# FARRELL RESIDENCE

# PROPOSED ONE-CAR GARAGE RECONSTRUCTION

**Farrell Residence** 32 Shrewsbury Avenue Block 43, Lot 7 Waterfront Transition-Residential (WT-R) Zone **First Completeness Review**

Re: **Farrell Residence** 32 Shrewsbury Avenue Block 43, Lot 7 Waterfront Transition-Residential (WT-R) Zone **Minor Site Plan with variances** First Engineering Review

GARAGE FLOOR PLAN SCALE: 1/4"=1'-0"

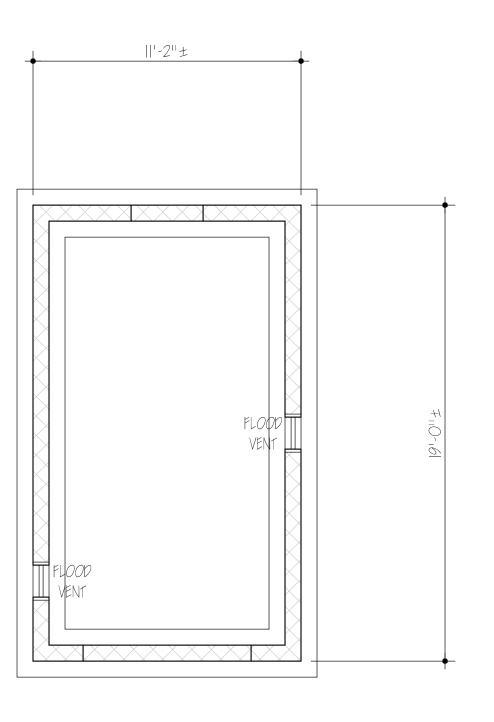
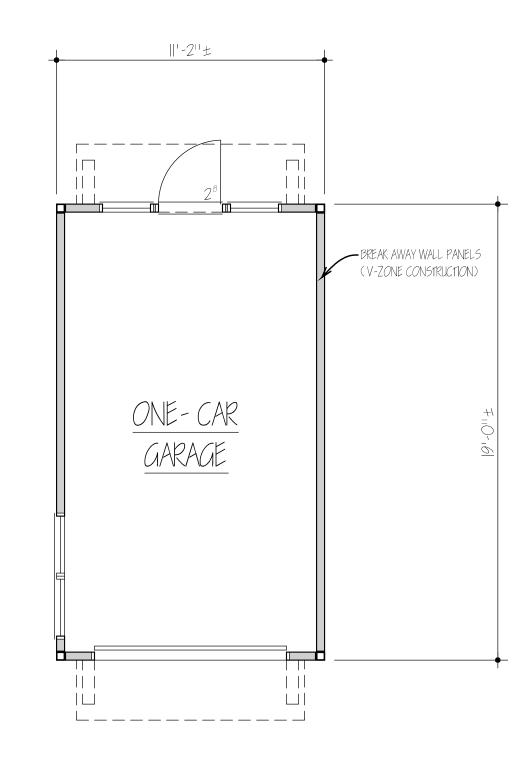
- 2. The applicant notes an eleven-inch (11") side yard setback to the proposed accessory garage from the southerly side property line abutting lot 6. It is presumed that this dimension is to the lower foundation wall. The elevations show additional eaves/decorative trim that expand the total width of the proposed building. The applicant should provide testimony and a sketch of the front elevation detailing the setbacks at the top of the building, including any gutters so that the outer limit of the structure and appurtenances is identified in relation to the side property line.

- 8. The applicant shall provide testimony on any drainage impacts to the adjacent residential properties as a result of this application. Gutters/downspouts should be shown if proposed. It is unclear how the flat roof will be drained.

- 1. Updated plan showing the existing and proposed setbacks and required setback lines.
- 2. The plan shall include additional detailing of the roof drains associated with the proposed garage including location and direction of discharge.
